**SUP15-01 (T&DGK Enterprises)**

<b>Request</b>	<p>Make a recommendation to City Council on a <b>Special Use Permit Application, SUP15-01 (T&amp;DGK Enterprises)</b>, to allow for a warehouse use [office/warehouse building] on approximately 0.996 acres of property zoned "CO" (Office Commercial), legally described as Abstract 3, Lot 1 of the Ghirardi #3 Subdivision, generally located at the northwest corner of Dickinson Avenue and Beaumont Street, with the approximate address being 601 Beaumont Street in League City, TX.</p> <p>The applicant proposes to develop a 6,000 square foot office/warehouse building, with 1,810 square feet of office and the remaining 4,190 square feet for warehouse. An additional 3,500 square feet of future expansion is proposed as well.</p>
<b>Applicant</b>	Cathy DeFoore, Wycoff Development
<b>Owner</b>	T&DGK Enterprises
<b>Acreage</b>	0.996 acres
<b>Location</b>	Generally located at the northeast corner of Dickinson Avenue and Beaumont Street, with the approximate address being 601 Beaumont Street in League City, TX.

SITE DEVELOPMENT & LANDSCAPING PLAN

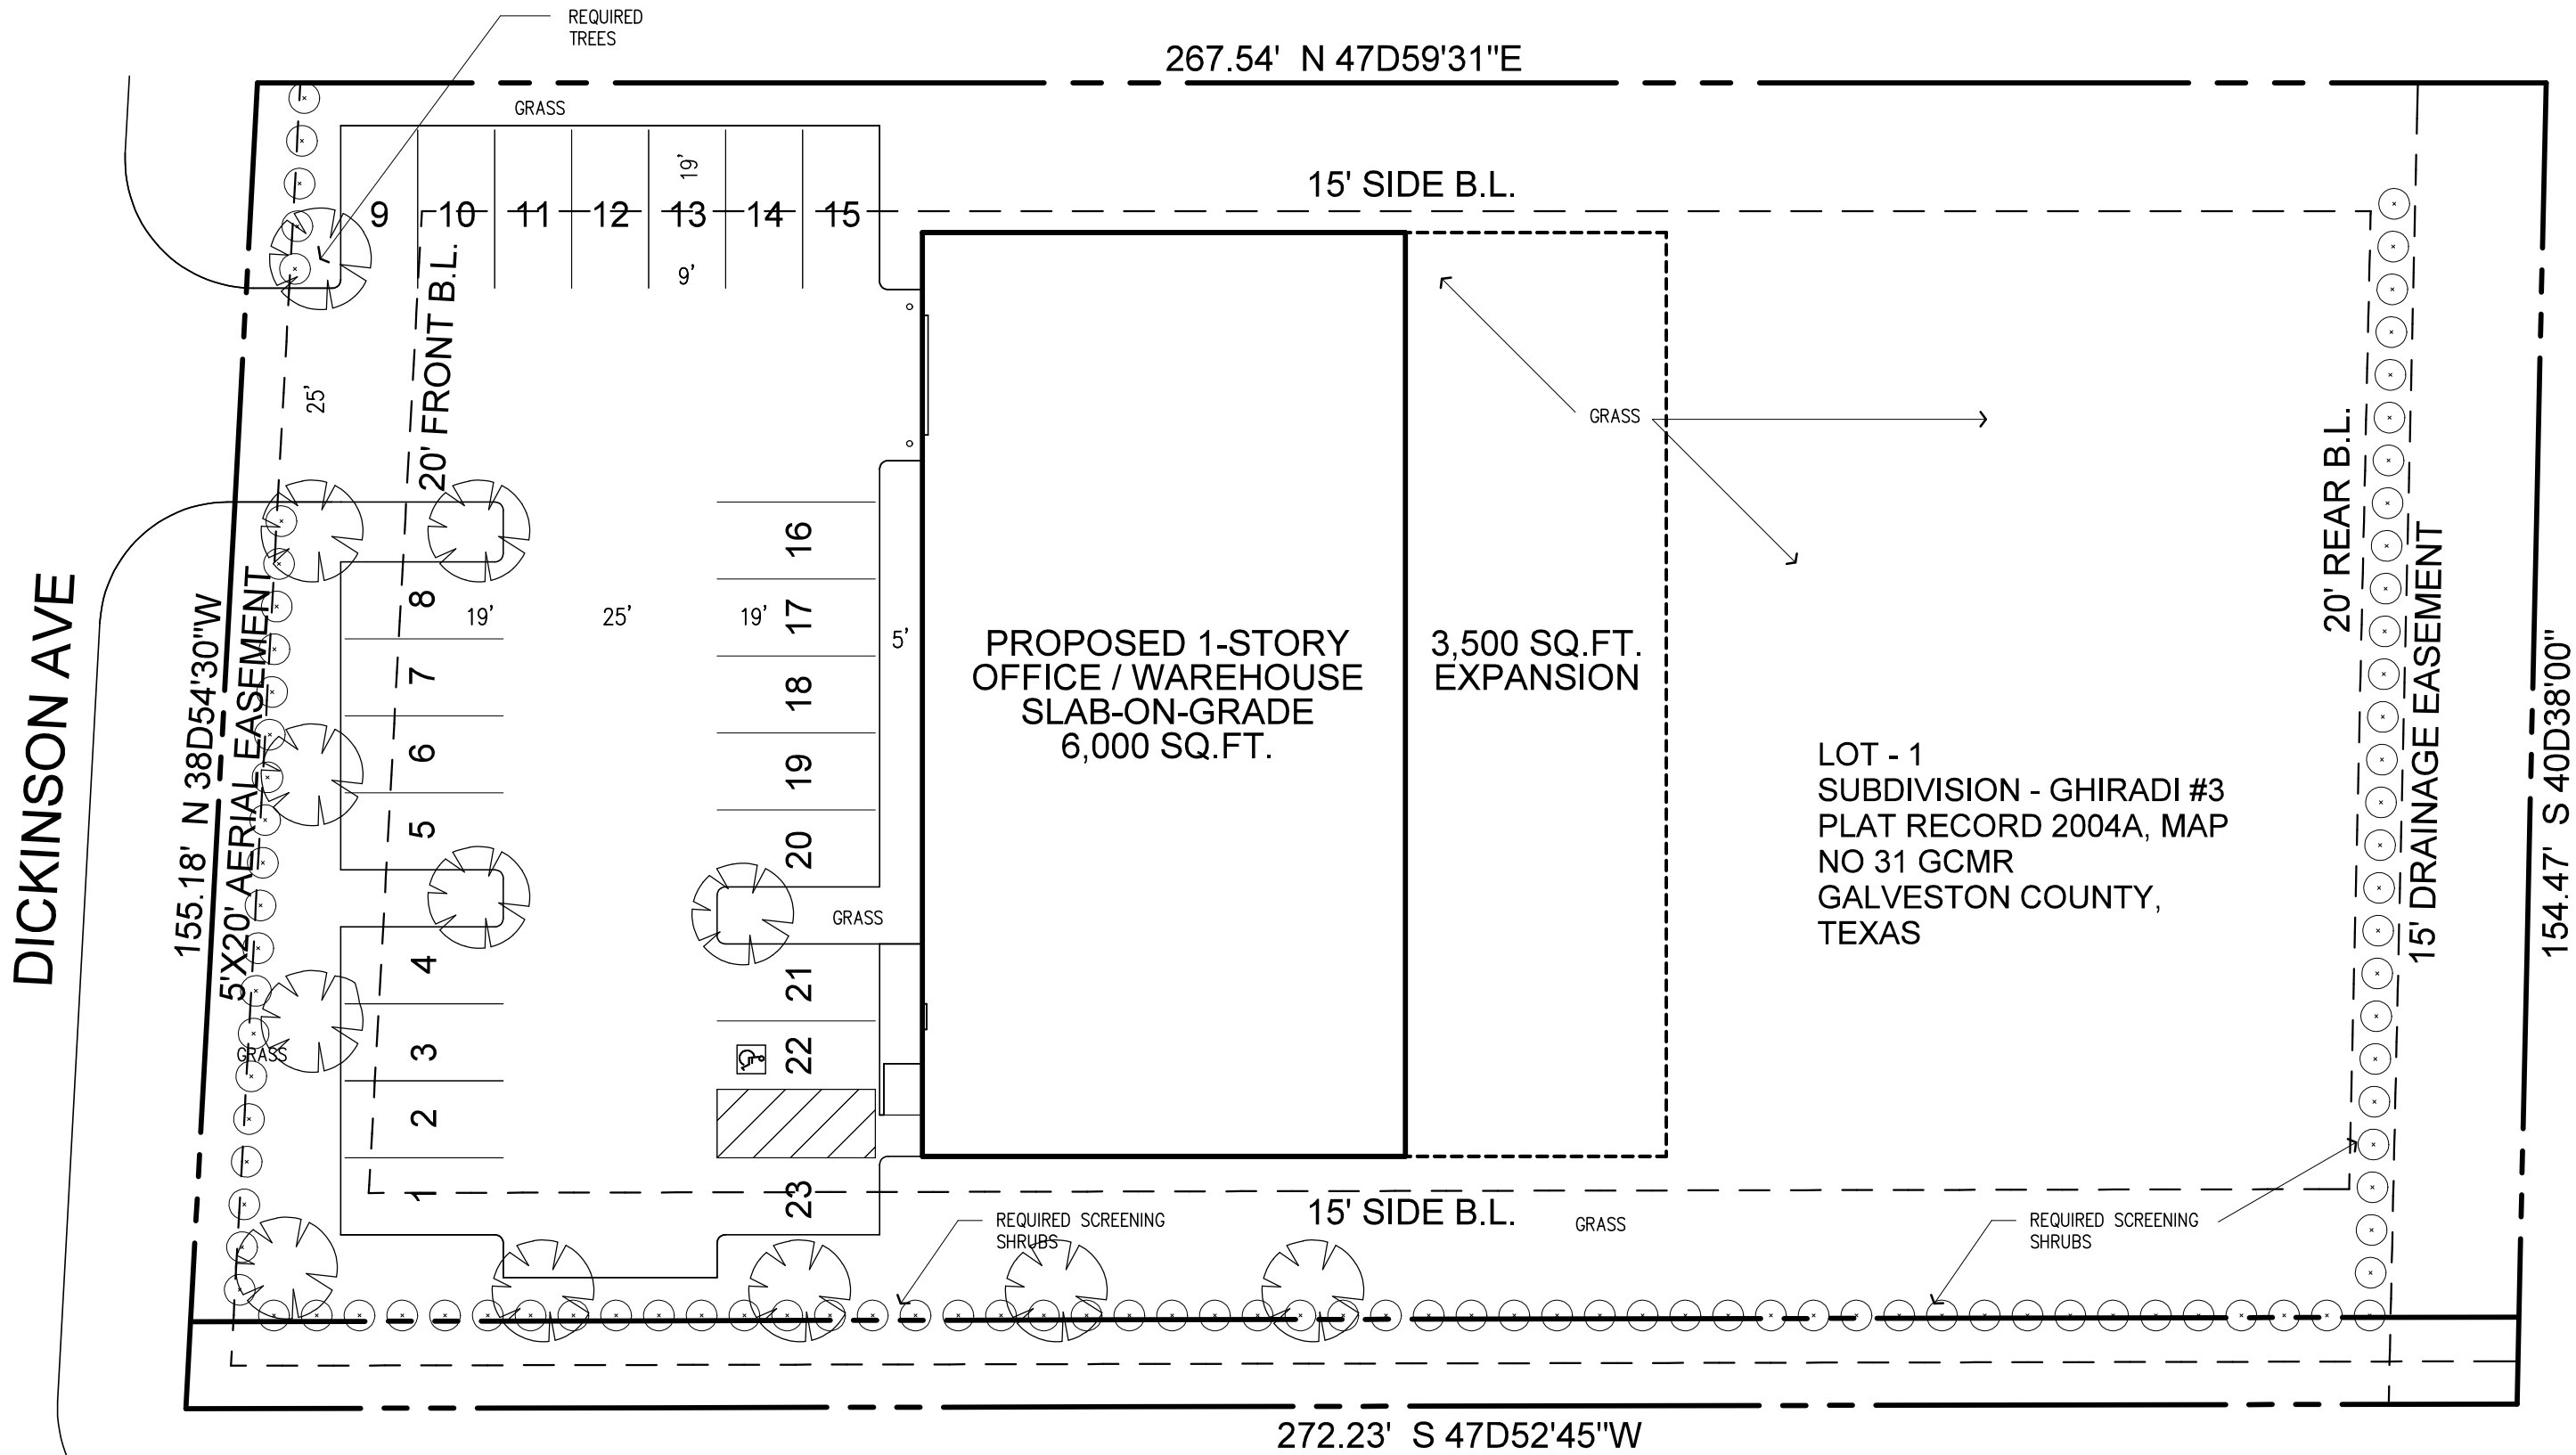
To further screen the building from Beaumont Street as well as the residential property to the east of the site, the applicant has added continuous shrubs along the southern and eastern property lines of the site. The shrubs will be the same species that will be screen the parking lot.

3. The elevations and site, including internal circulation and parking, shall conform to the conceptual site plan and elevations as shown in Attachments #4 and #5.
4. No truck traffic shall be permitted on Beaumont Avenue and no vehicular access shall be permitted from Beaumont Street.
5. Landscaping, including screening, shall conform to the landscaping shown on the conceptual site plan. A minimum of 25% of the site shall consist of landscaping or open space.

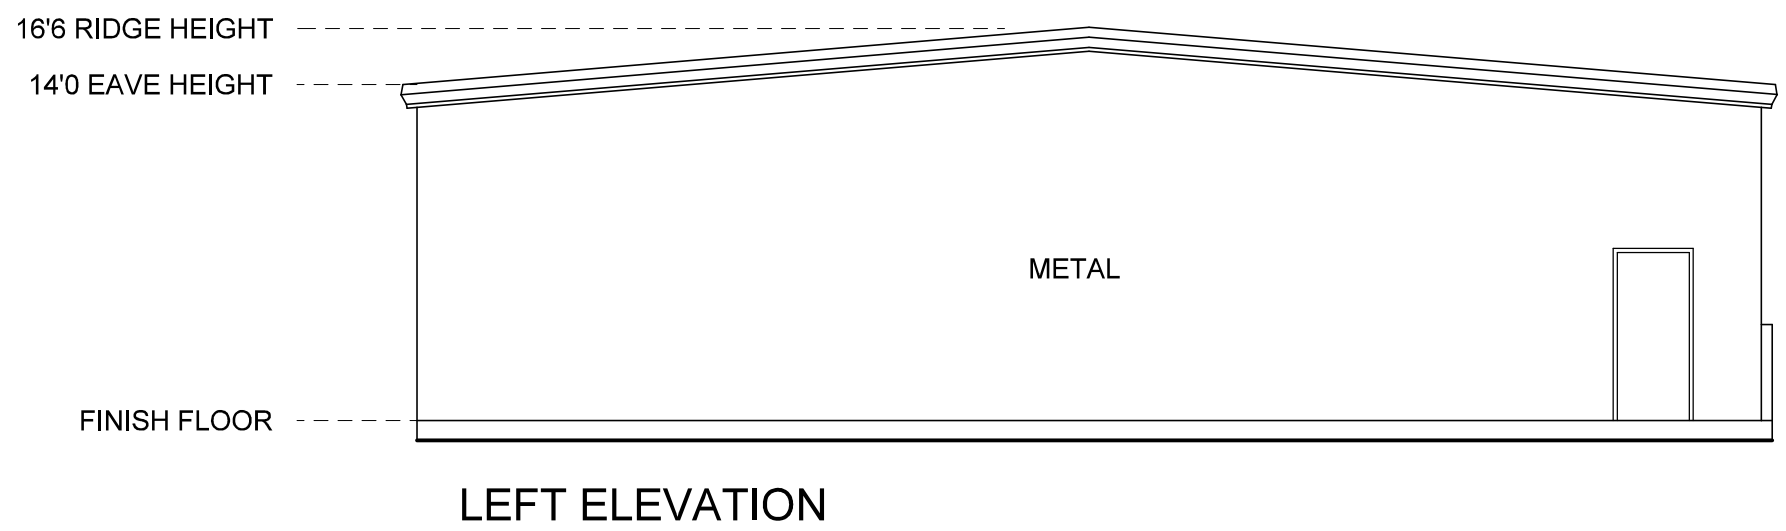
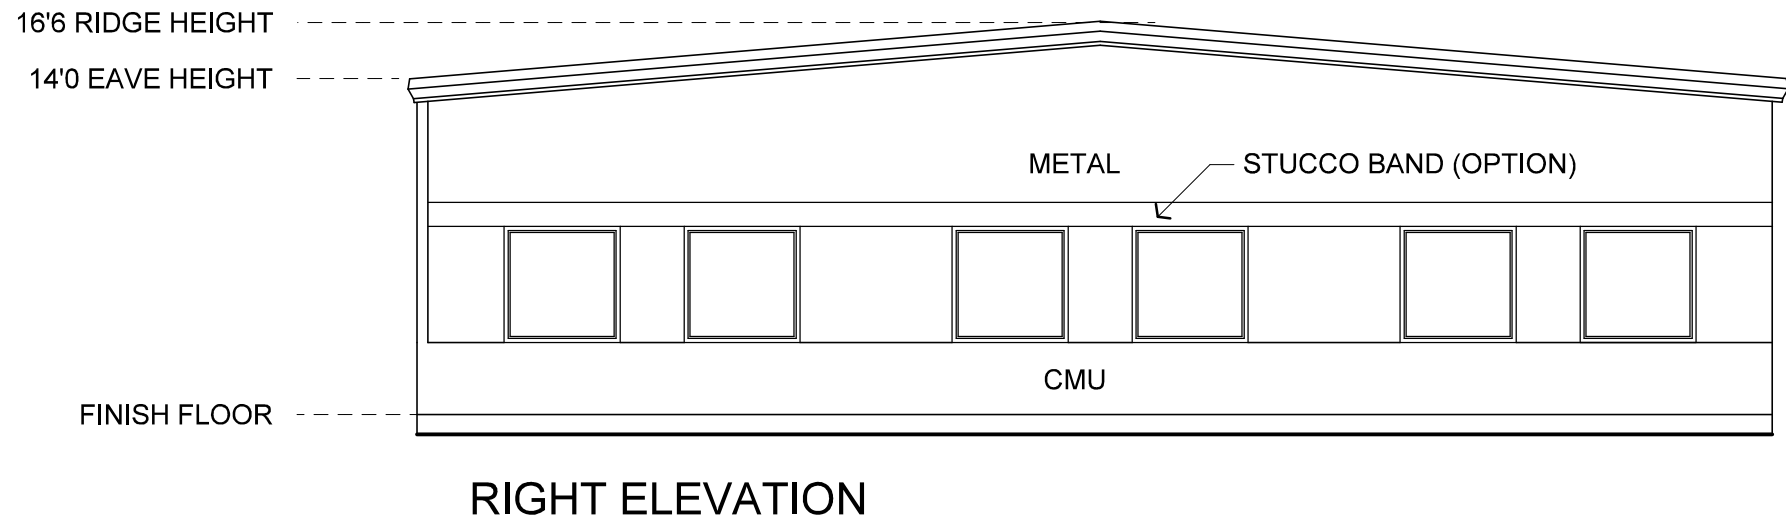
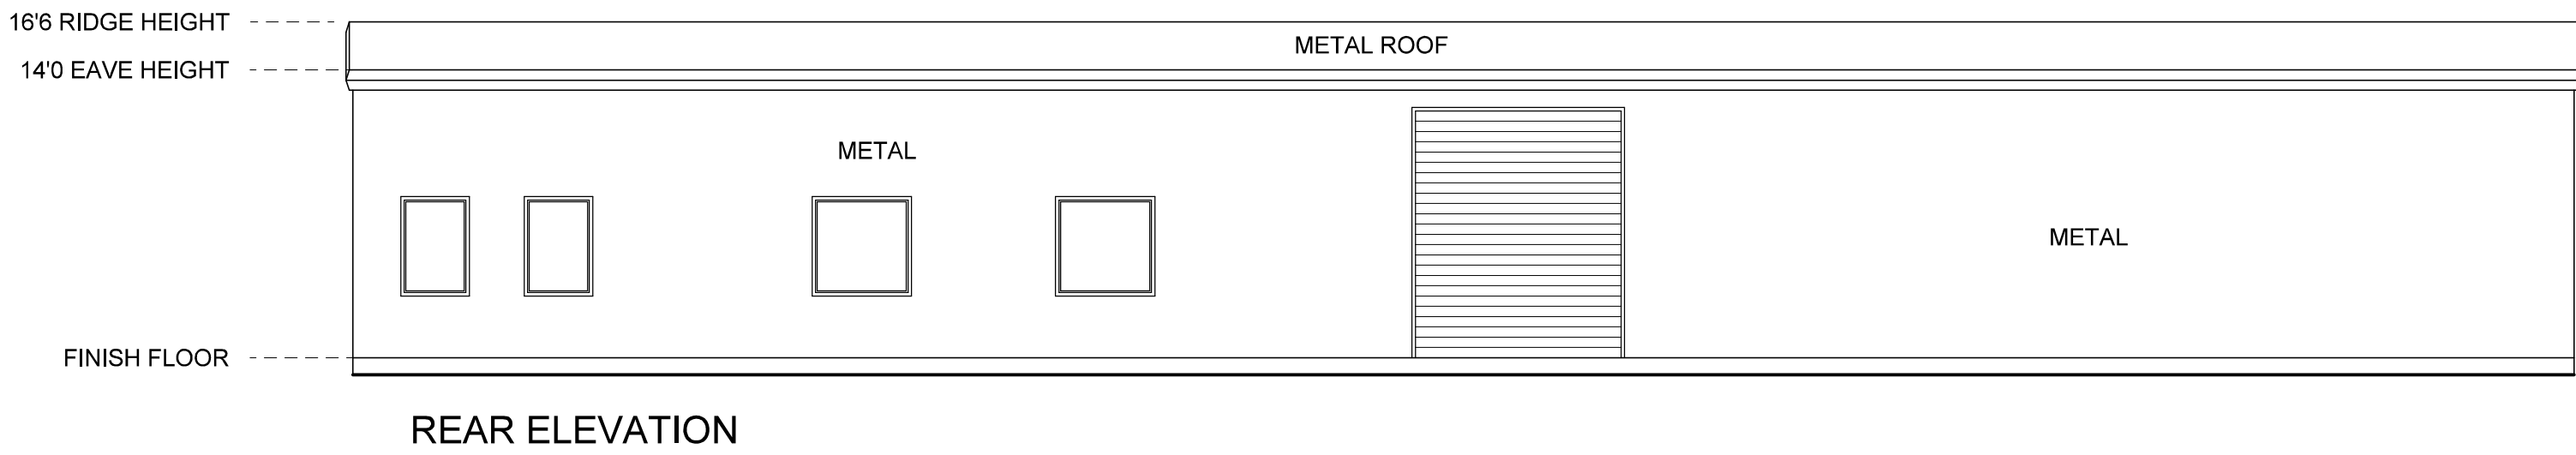
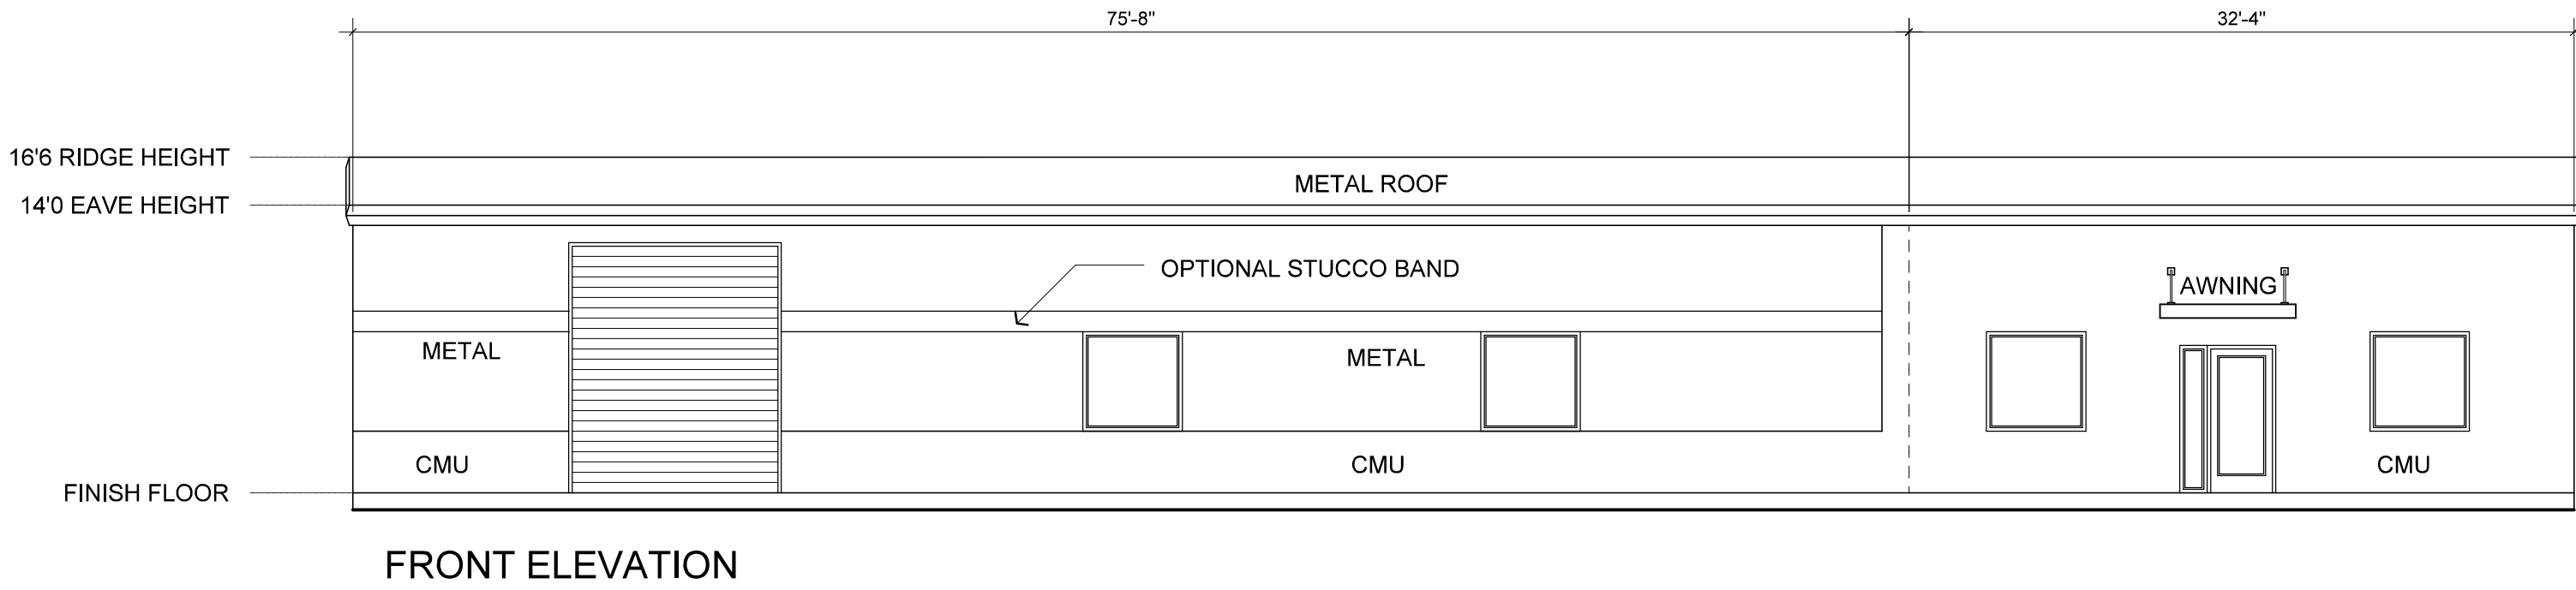
<b>Background</b>	A public hearing was held by the Planning and Zoning Commission on this application on February 16, 2015. The Planning and Zoning Commission tabled this item until the March 2, 2015 meeting in order to give the applicant more time to address the Commission's concerns regarding architecture, screening, and truck traffic.
<b>Changes to Building Architecture</b>	The applicant has revised the building to make it more compatible with the residential character to the south and east of the site. An optional stucco band has been added to the elevations to make the building more compatible with the residential character to the south and east of the site. The applicant has made the band optional, pending Planning and Zoning Commission action, because of their concerns of potential water damage because of the stucco location. According to the applicant, placing a stucco band above the windows could cause water to pool above the windows eventually

making them leak. Without the stucco, staff still recommends that the architecture of the front and right elevations is “softened” by lessening the amount of metal visible on those elevations.

1. The Special Use Permit shall expire after a period of 12 months beginning upon the date of the adoption of the SUP ordinance if no formal application is submitted to the City for development of the site.
2. The uses permitted on the site will be limited to those permitted in the base zoning district and identified by this Special Use Permit. The only use permitted by this SUP is an office/warehouse building.
3. The site shall be similar to that shown on the conceptual plan, including the internal circulation and parking layout.
4. No vehicular access shall be permitted from Beaumont Street.
5. A minimum of 25% of the site shall consist of landscaping or open space.
6. The front and right facades fronting Dickinson Avenue and Beaumont Street shall have a

minimum of 25% transparency.
